APPLICATION FOR PERCOLATION TESTING AND SITE EVALUATION

SUBDIVISION/PROPERTY NAME Weinberg Residence LOT # _____

PROPERTY ADDRESS 6655 Mink Hollow Rd
STREET TOWN ZIP

RE: Percolation Test Report; 6655 Mink Hollow Road (Tax Map 34, Parcels 283)

Sheet 1 of 2

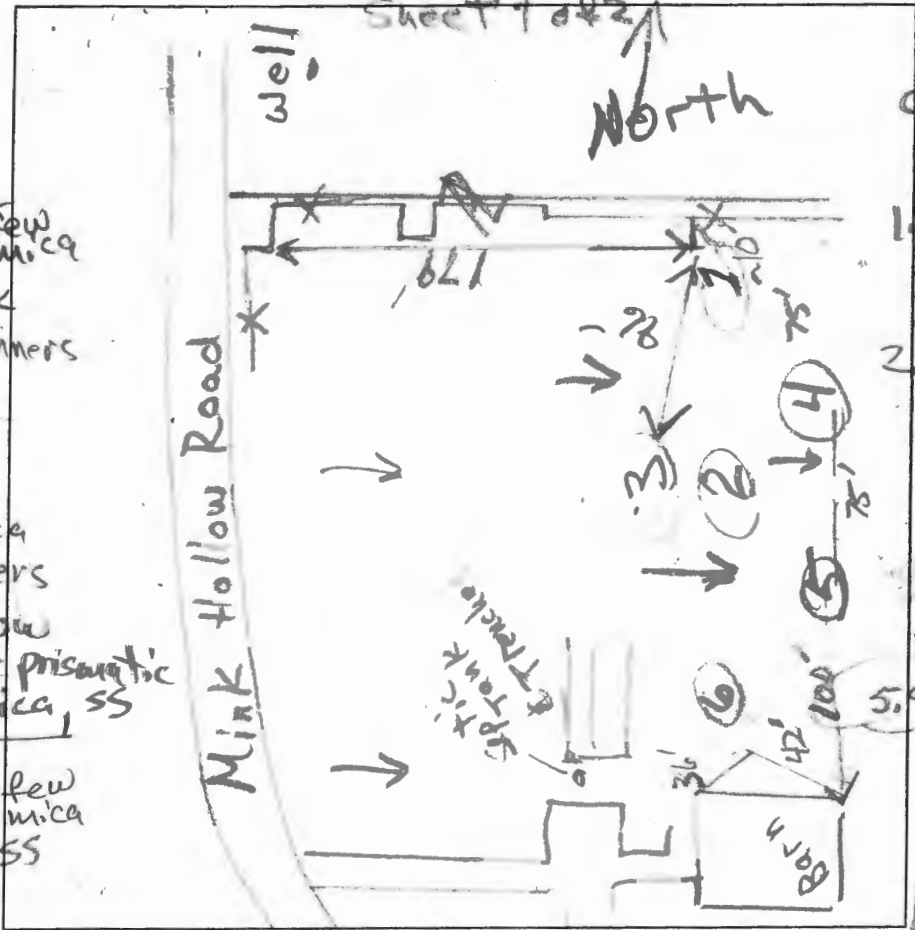
DATE	TEST #	DEPTH	START	BREAK 1" DROP	STOP 2" DROP	TIME OF 2ND INCH	P/F/H
4/9/15	3	8.2/15'	10:25	11:00			reshelf
	3	10.3/15'	11:10	11:45			F
4/9/15	6	8'/13'	11:20	11:24	11:34	10	P
4/9/15	1	7.5/13.5'	11:45	11:57	12:27	30	P
4/9/15	2	8'/13'	12:45	12:52	1:10	18	P

REMARKS: SANITARIAN & Bricker BACKHOE Fogle's OTHERS (5) m 1/2 p (dk brn)
